INFN
RICH Detector for Hall B

MECHANICAL REVIEW
REPORT

BACKGROUND OVERVIEW & COMMITTEE CHARGE

Figure 1: View Showing Clearance Between RICH, R3, and FTOF

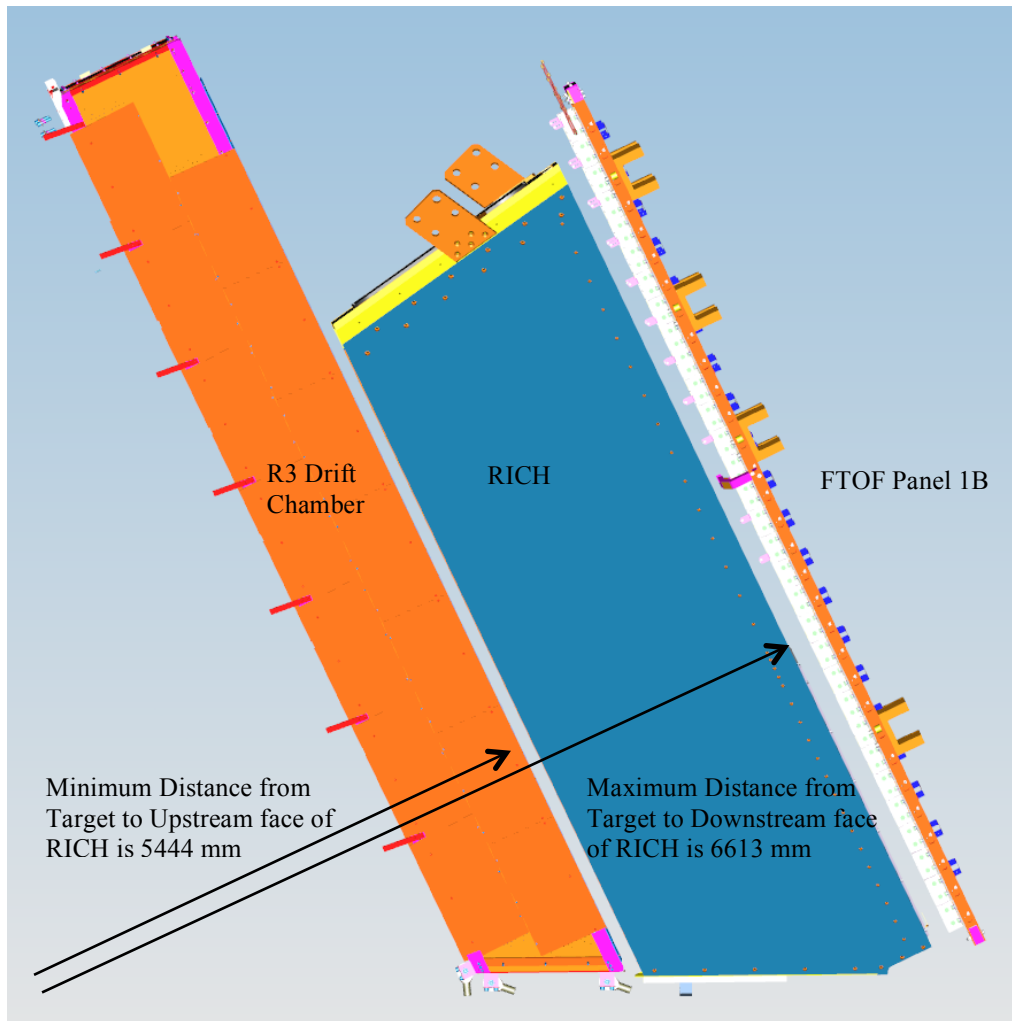
1. The INFN team provided a 3D model of the RICH detector and the LTCC. The model was placed in the Hall model at the final LTCC location. As shown in Figure 1, the minimum distance from the target to the most upstream portion of the RICH detector is 5444 mm. The maximum distance from the target to the most downstream portion of the RICH detector is 6613 mm.
2. The clearances were checked to the forward carriage structure and the adjacent detectors and the 3D model shows that the RICH detector fits in the space allotted; see Figure 2. Jlab will provide a 3D file of the final location of the RICH detector and the mount locations, as well as a file showing the Torus cryostat shadow on the RICH detector by July 11, 2014.

Figure 2: RICH Detector Attached to Forward Carriage Mounting Brackets

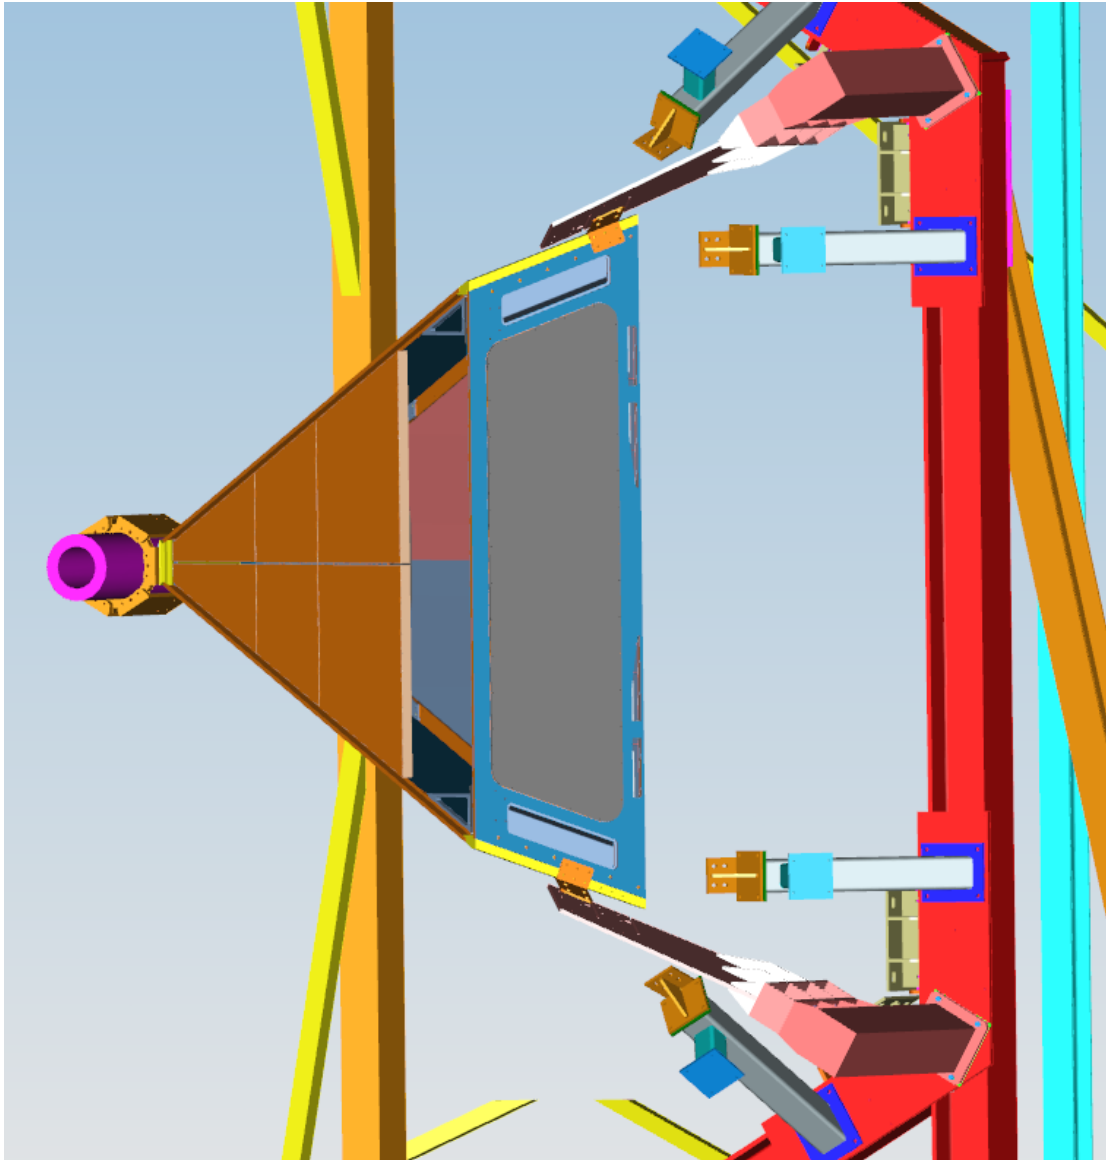
1. The RICH detector will fit through the truck ramp horizontal if one of the mounting stirrups are removed. The LTCCs were removed using this method and since then, the door width has been increased by 4 inches. See Figure 3.
